SUBJECT: Forwards marked-up FSAR pages describing equipment for sampling & monitoring process & effluent streams during postulated accidents. Submittal closes out commitment in Section 11.5.2. (Page 11-14) of SER, NUREG-0892.

Docket No. 50-397

Subject: NUCLEAR PROJECT NO. 2
PROCESS AND EFFLUENT RADIOLOGICAL MONITORING
AND SAMPLING SYSTEMS

Attached are sixty (60) copies of marked up FSAR pages describing WNP-2 equipment for sampling and monitoring process and effluent streams during postulated accidents.

TURBINE BUILDING VENTILATION RELEASE DUCT MONITOR

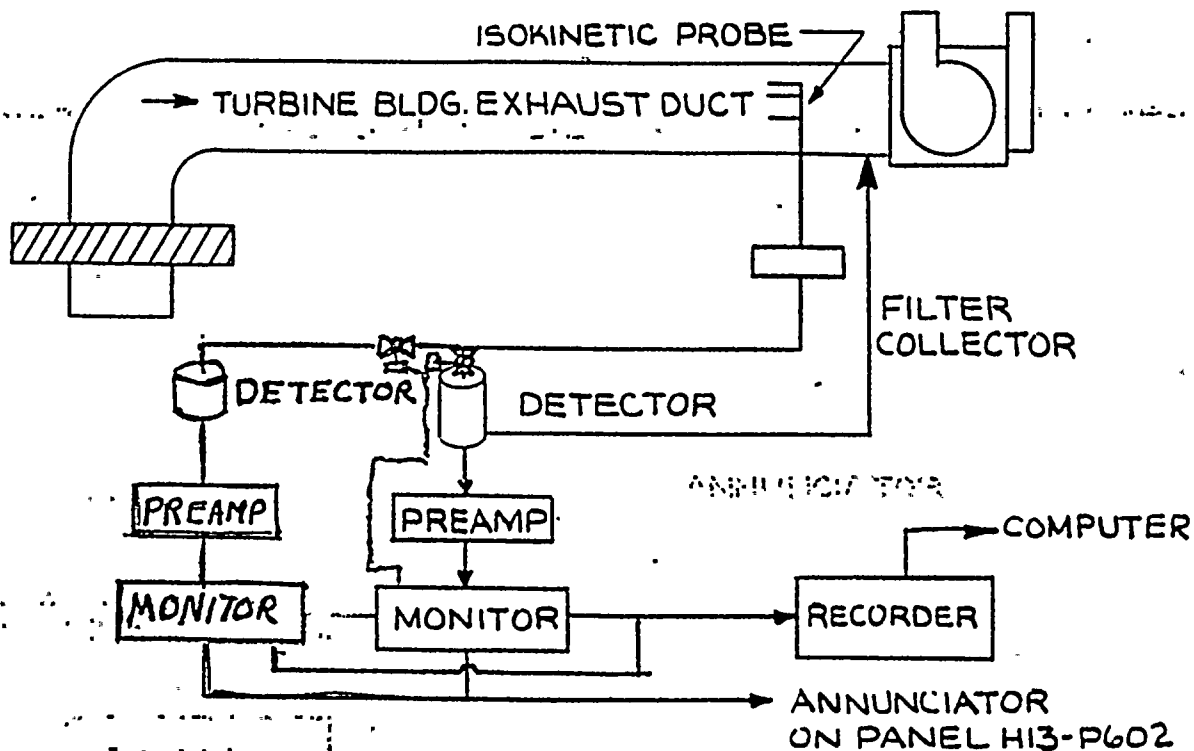
Each The gas monitors ARE mounted in a heavily shielded chambers. The gas channel consists of the local detector and pre-amplifier count rate meter and a recorder in the main control room. Arrangement details are shown on Figure 11.5-6.

INSELF HEAD These monitors have no control functions. There are two adjustable trip circuits, one high for high radiation alarm, and one low for instrument inoperative that annunciate in the main control room. The power supply is from an uninterruptable power source.

The low range (10^{-6} μ Ci/cc to 10^{-1} μ Ci/cc) gas channel receives the normal sample flow. If the gas activity increases high enough to trip the high-high alarm then the sample flow valving will change to direct the sample through the high range (10^{-2} μ Ci/cc to 10^3 μ Ci/cc) gas channel.

RADWASTE BLDG VENTILATION RELEASE DUCTS MONITOR

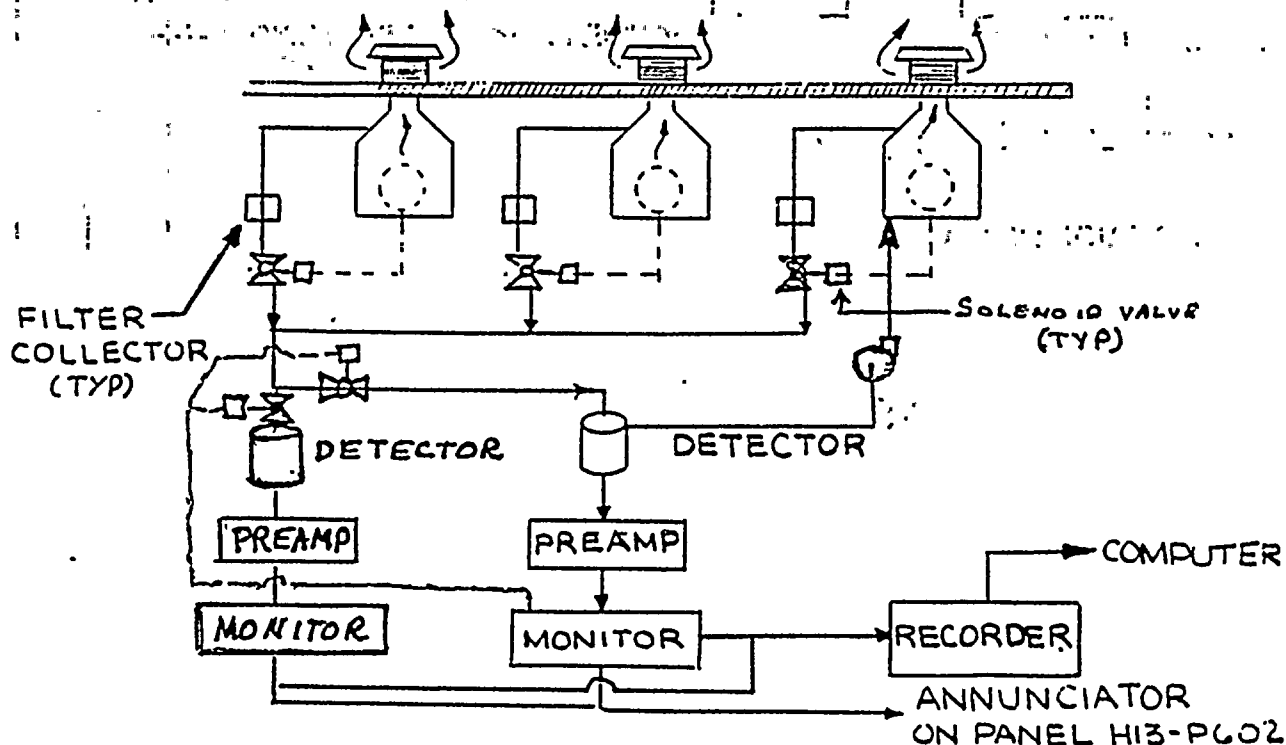
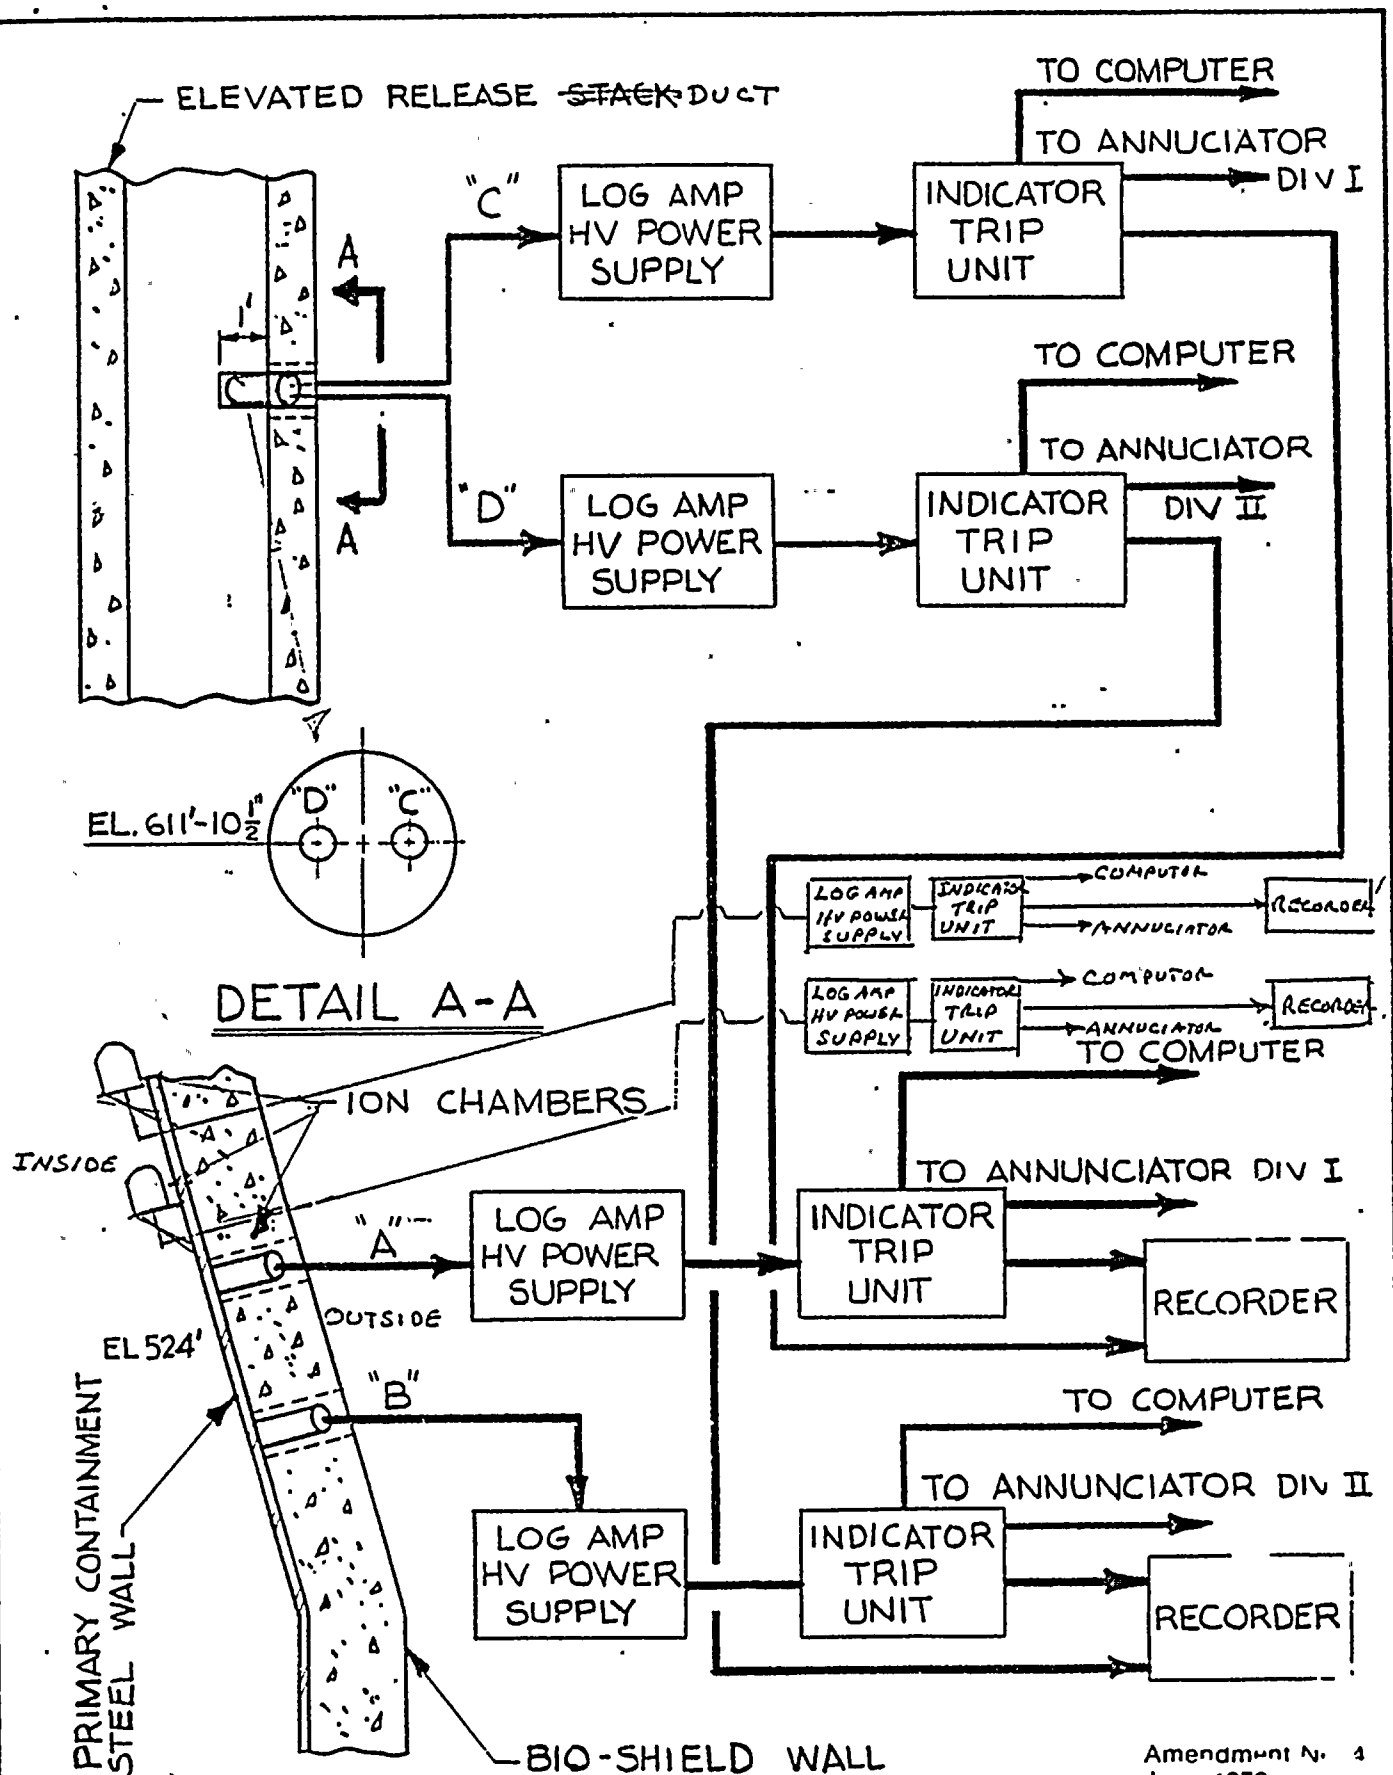
This monitor system measures the radioactivity in the radwaste building ventilation air exhaust as it is being discharged to the environment and in doing so complies with Regulatory Guide 1.21, Rev. 1 and, Design Criterion 64. Radioactivity originates from radwaste tank vents, from primary water processing equipment and from laboratory sampling hoods as well as various cubicles having liquid process treatment systems within the building. A continuous sample is drawn from each of the two out of three fan exhausters that are operating. The representative sample is withdrawn through a duct probe, ^{AND NUR 64 0737} ^{MULTIPOSED ISOTHERMIC DOWN A 10 Foot tub} ^{TO} passes through a particulate filter to collect particulates, ^{AND} ^{ISOLINE} ^{then} through a charcoal filter to collect halogens. Filters are exchanged at least weekly for laboratory radiochemical analyses. The filter air sample streams are combined to pass through ^{ONE OF TWO} a single gas monitors.

The gas monitors ^{ARE} ~~is~~ mounted in a heavily shielded chambers. ^{EACH} The gas channel consists of a local detector and preamplifier with countrate meter and a recorder in the main control room.

^{ESSE} ~~This~~ ^{VE} monitors has ^{EACH MONITOR HAS} no control functions. ^{AND ONE HIGH-HIGH} There are ^{two} adjustable trip circuits, one high, for high radiation alarming, ^{AND PLUS A} one low for instrument inoperative that annunciate in the main control room. ^{THE POWER SUPPLY IS FROM AN UNINTERRUPTABLE POWER SUPPLY.} (Also see App. B section II. F. 1.1)
